Cover Letter – FMS2

Machine Sensor Art No 584 91 89 05

This cover letter is to clarify difference and similarities in-between HW and SW changes used during the certification process and during production of the sensor.

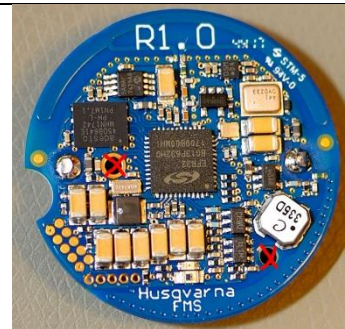
HW - revision	Comments
P1.2 A Prototype, not sold	PCBA used during certification
P1.2 B Prototype, not sold	Updated SoC with more RAM compared to P1.2 A. PCBA used during certification
R1.0 A Released	Identical to P1.2 B except: Color on PCB is blue. Some via holes are not covered by coating.
R1.1 A Released	Identical to P1.2 B except for the color on the PCB that is blue instead of green
R1.2 A Released	Identical to R1.1 but the two bigger holes on the PCB are covered to facilitate automatic machine coating of the board. See red X on photo.
